# Mahler Water Reclamation Facility (MWRF) Interim Improvements

## ADDENDUM NO. 4

### SLUDGE BLEND TANK DESIGN-BUILD

SITE DEMOLITION & TREE REMOVAL PLAN			
PROJECT NO.: 936-50-21-09	SCALE:	AS SHOWN	DATE: JANUARY 2023

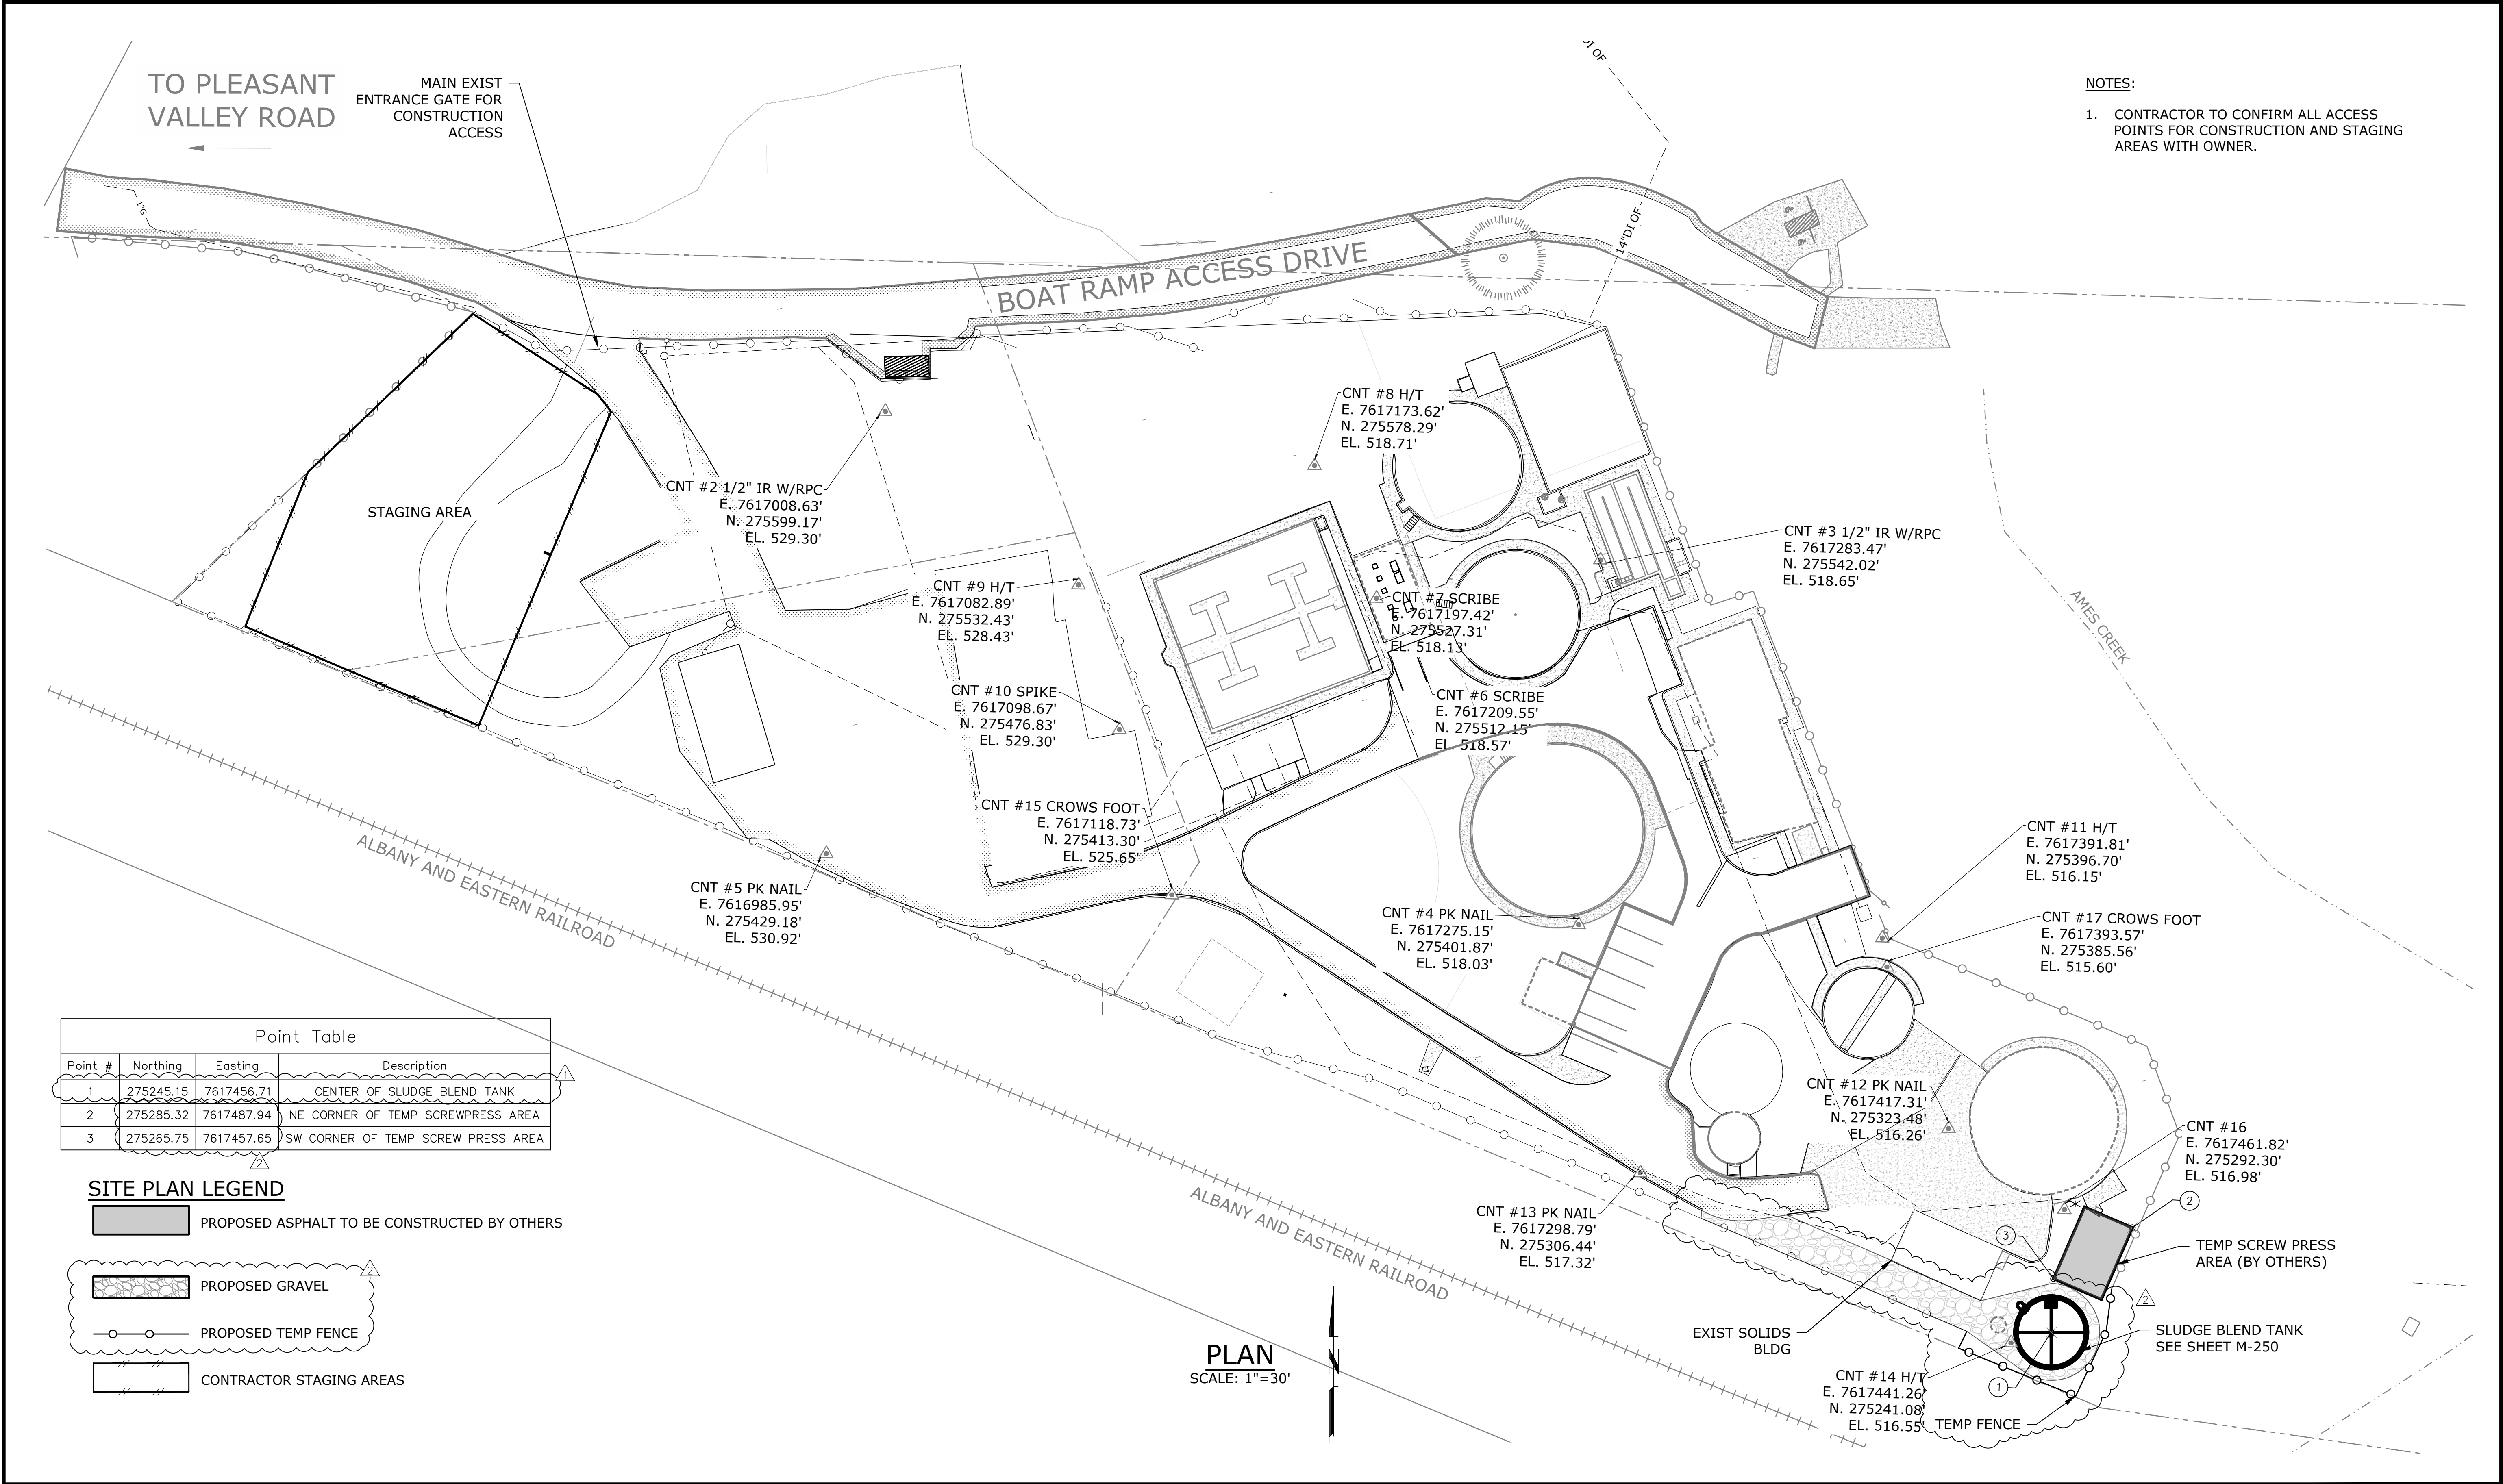
- Q1.** Would it be possible to predetermine the trees prior to falling them that the city would like to keep?
- A.** The City does not want to salvage the trees removed as part of this contract. See updates to the demo sheet, C-005 for trees to be removed.

**C-010**

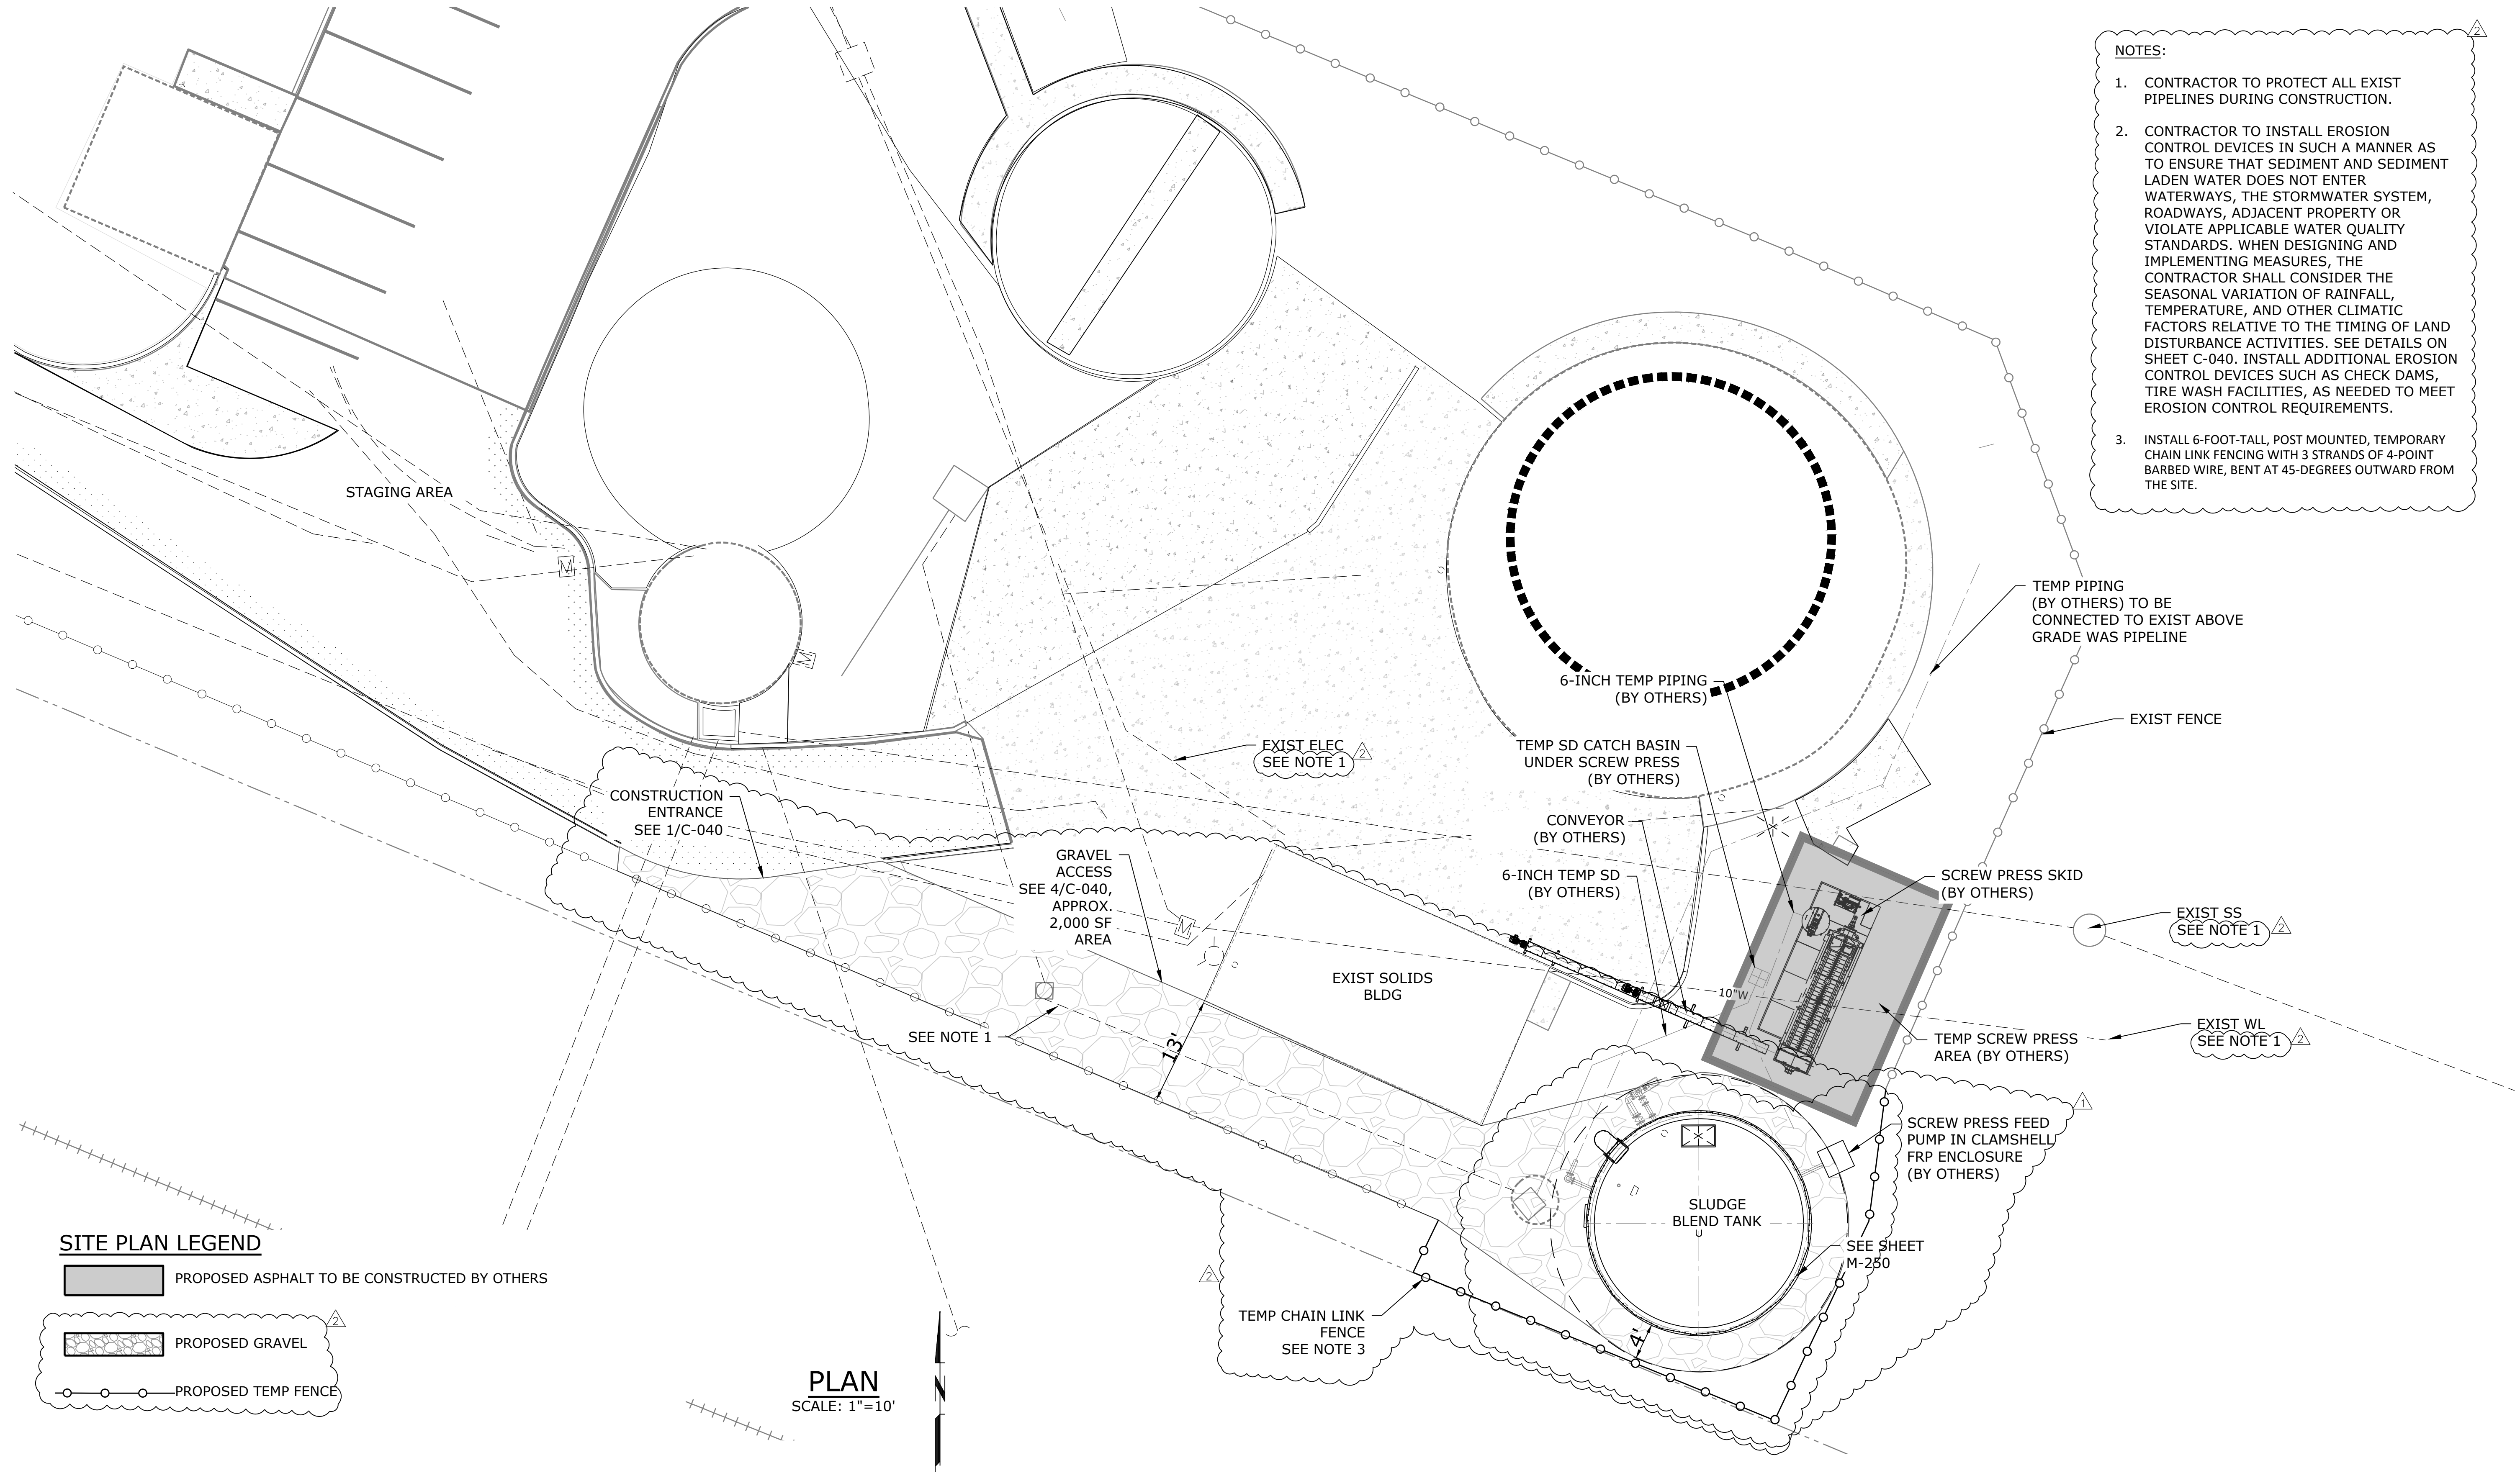
- Q3.** Is it possible to define the area of the site to be finished with gravel?
- A.** See revised attached drawings.
- Q4.** We anticipate taking the fencing out in the working areas and disposed of. Are you looking for us to put in temporary fencing?
